**SIGN-24-74****Sign Permit**

Install Freestanding Off-Premise Advertising Sign with LED Digital Faces

RE: Sign Permit: SIGN-24-74
0 Atlanta Rd
17044400280

Selective Structures, LLC
811 East Avenue
Athens, TN 37303
▼
10'-6" x 36'-0" FF, 15V @ 40'-0" O.A.H.
w/Up to Two (2) 4.725# Digital Displays
Located In: Smyrna, GA

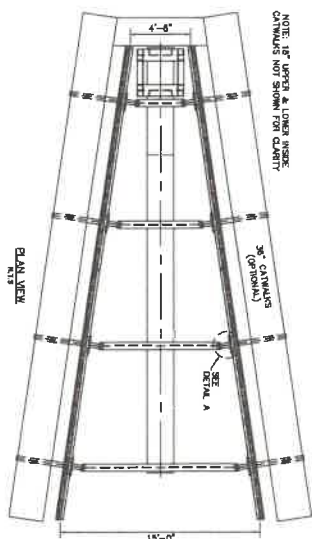
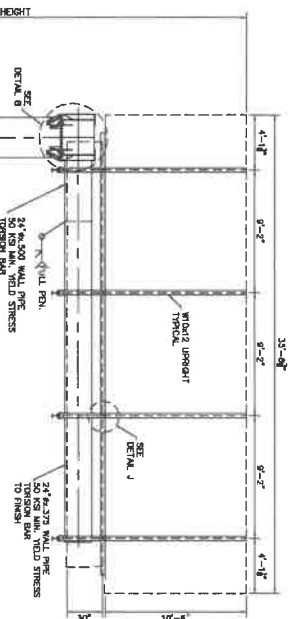
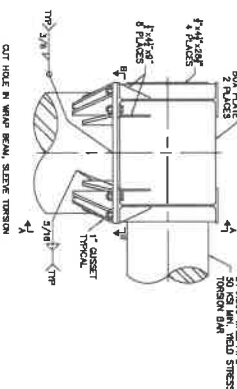
This sign permit is denied based on the non-compliance with the regulations established in Chapter 82, Section 15 of the Smyrna Code of Ordinances. The proposed sign exceeds both the maximum area (32 square feet) and maximum height (8 feet) specified by the ordinance, is not a ground based monument sign as required by the ordinance and is a pole sign as prohibited by the ordinance.

The application for permit SIGN-24-74 is denied based on the non-compliance with the regulations established in Chapter 82, Section 15 of the Smyrna Code of Ordinances. The proposed sign exceeds both the maximum area (32 square feet) and maximum height (8 feet) specified by the ordinance, is not a ground based monument sign as required by the ordinance and is a pole sign as prohibited by the ordinance.
